SERVICE BULLETIN NO. MSB1078-103

ATA-Code: 25-10
Baggage compartment cover

G 115D
G 115E
G 115EG

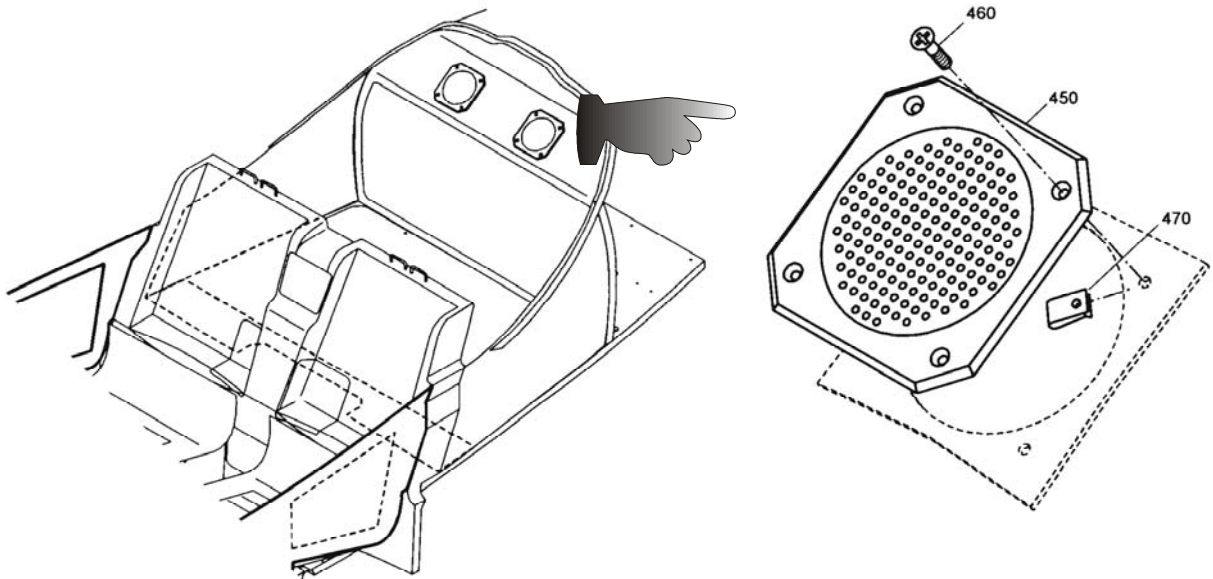
Due to different modifications, including canopy sealing improvement an increase of the carbon monoxide concentration might be possible. To reduce the carbon monoxide concentration in the cockpit, the loud speaker cover, installed in the baggage compartment, must be replaced by a new closed cover plate.

- remove screws (item 460, qty. 8) and remove loudspeaker covers (item 450)
- install new cover plate P/N 115E-2000.40 using screws (item 460)
